Subject: FW: Scio Church Crosswalks

Greetings, all. I had a conversation with Cynthia recently about the Scio Church project and I understand that the plans that are posted on the project web site are not going to be changed to include any refuge islands, since they can't fit without inhibiting left turns or driveway entrances.

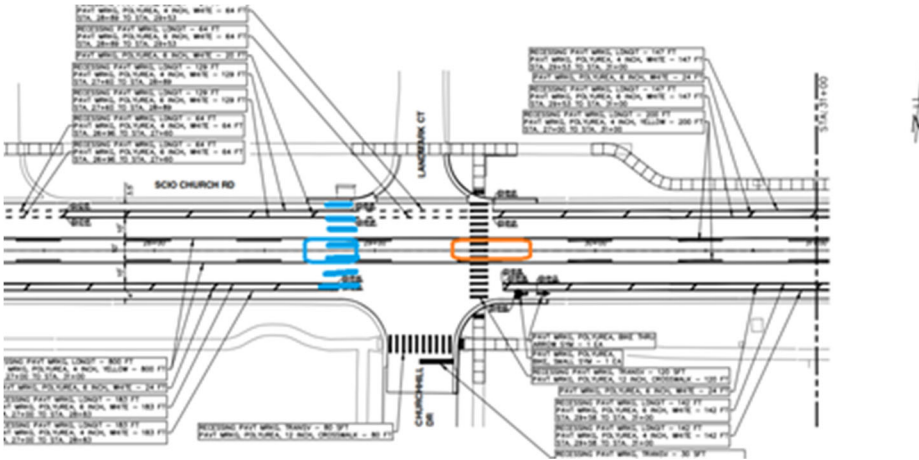
However, if the crosswalk and a refuge island were installed on the west side of Churchill (in blue in the picture below), then the only turning movements that would be affected would be those going onto Landmark

Ct. There are only 4 residences on Landmark Ct. Can the left turns onto Landmark happen from the through lane? If so, then a refuge island may fit. But if we put the crosswalk on the east side (as planned now) then adding a refuge island now or in the future is not an option without moving the entire crosswalk.

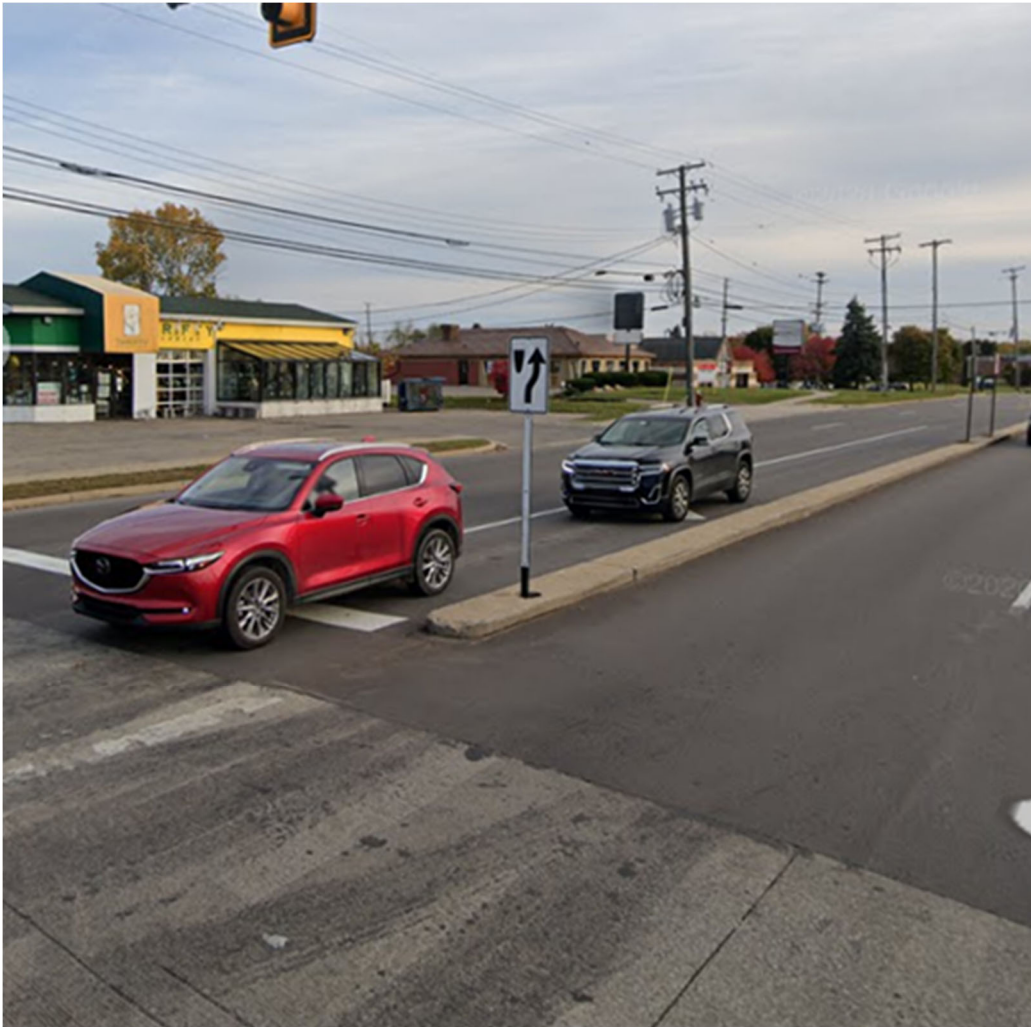
Firstly, refuge islands might inhibit left turns, but this can be mitigated at two of the crosswalks. At Churchill, an island on the east side of the intersection (where the crosswalk is now planned) would indeed inhibit left turns into Churchill Downs neighborhood, which has approximately 100 residences. But adding that feature to the west side of the intersection would inhibit left turns onto Landmark Ct., which has only 4 residences and no outlet. Maybe one option would be to move the crosswalk west and add a refuge island there. Similarly, at the Covington crosswalk, there is no southbound street at that intersection. Adding a refuge island or a narrow median on the east side of the intersection would not inhibit any left turns.

I'd also like to draw attention to the extreme width of Scio Church. With 45', we would have room for two 5' bike lanes, two 10' through lanes, one 10' turn lane and still have 5' left over for a refuge island. I don't necessarily think that's the best plan, but it does illustrate exactly how much pavement there is on this road. Please, let's try and repurpose more of it to support safety features for motorists, pedestrians and cyclists.

Lastly, the real issue here is that drivers misuse the center lane. It's possible that the existing crosswalk design (plus RRFBs!) would be adequate, IF some other features would deter misuse of the center lane. A narrow median at the intersections (like the attached picture) would make it obvious that the center lane is only for left turns and not to be used as a through lane or for passing.

We do not have time to make possible changes to the location of the crosswalk at Churchill and the possibility of adding medians at that crosswalk and near Covington, however it is something that could be added after the project advertisement. Our design staff can revisit your concerns before construction.

In regard to the pavement width, we have added a buffered bike lane on both sides of the street which utilizes that extra 5 feet you mentioned. This also reduces the crossing length for pedestrians as well as adding protection for cyclists.
